<b>Title of Change:</b>	AR0833CS Datasheet Update		
<b>Effective date:</b>	12 June 2018		
<b>Contact information:</b>	Contact your local ON Semiconductor Sales Office or <Sonya.Yip@onsemi.com>		
<b>Type of notification:</b>	This Product Bulletin is for notification purposes only. ON Semiconductor will proceed with implementation of this change upon publication of this Product Bulletin.		
<b>Change category:</b>	<input type="checkbox"/> Wafer Fab Change <input type="checkbox"/> Assembly Change <input type="checkbox"/> Test Change <input checked="" type="checkbox"/> Other: <u>Documentation</u>		
<b>Change Sub-Category(s):</b>	<input type="checkbox"/> Manufacturing Site Change/Addition <input type="checkbox"/> Material Change <input checked="" type="checkbox"/> Datasheet/Product Doc change <input type="checkbox"/> Manufacturing Process Change <input type="checkbox"/> Product specific change <input type="checkbox"/> Shipping/Packaging/Marking <input type="checkbox"/> Other: _____

**AR0833 Datasheet Change**

1. Updated Figure 44, Chief Ray Angle (CRA) vs. Image Height to the correct 12° CRA figure.

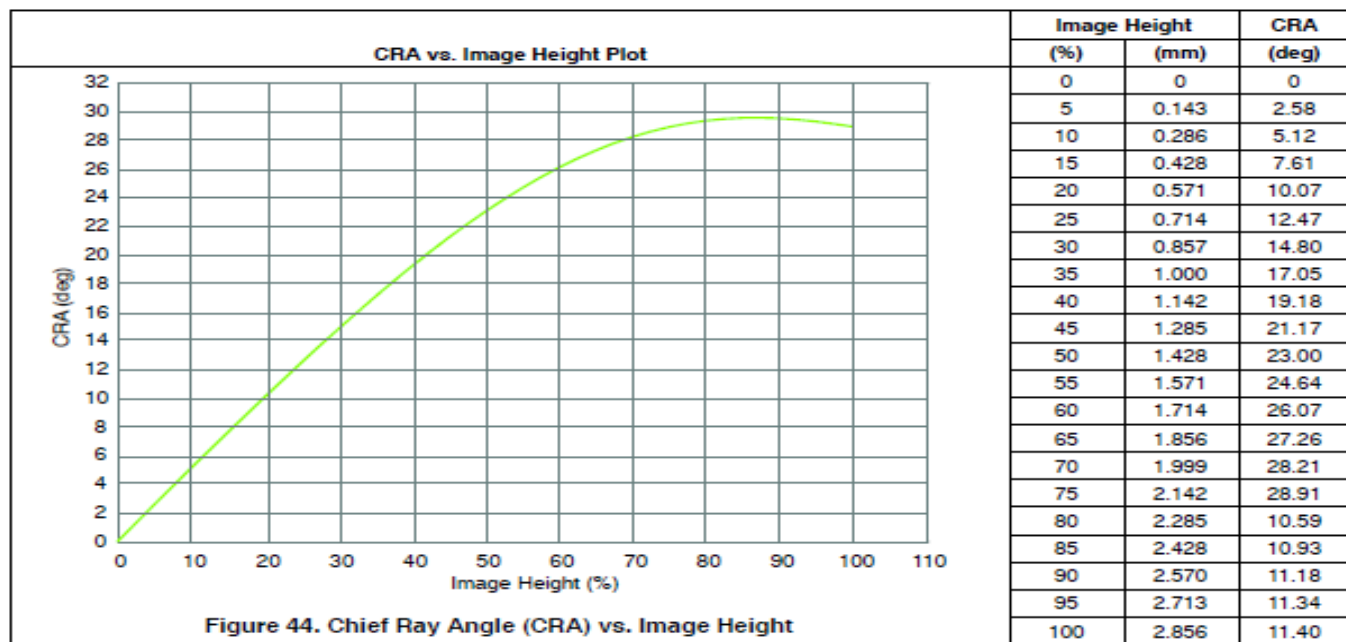
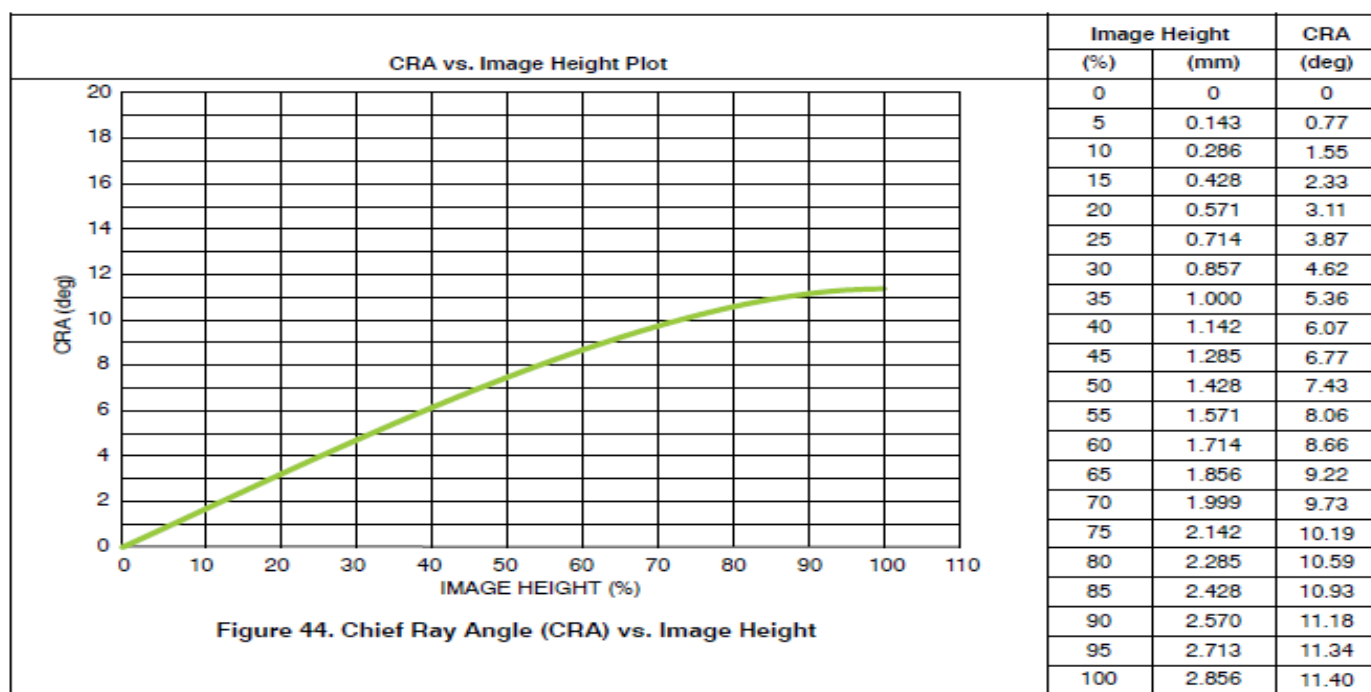
AR0833 Datasheet was updated to correct a documentation error. These changes do affect form, fit, or function of the product.
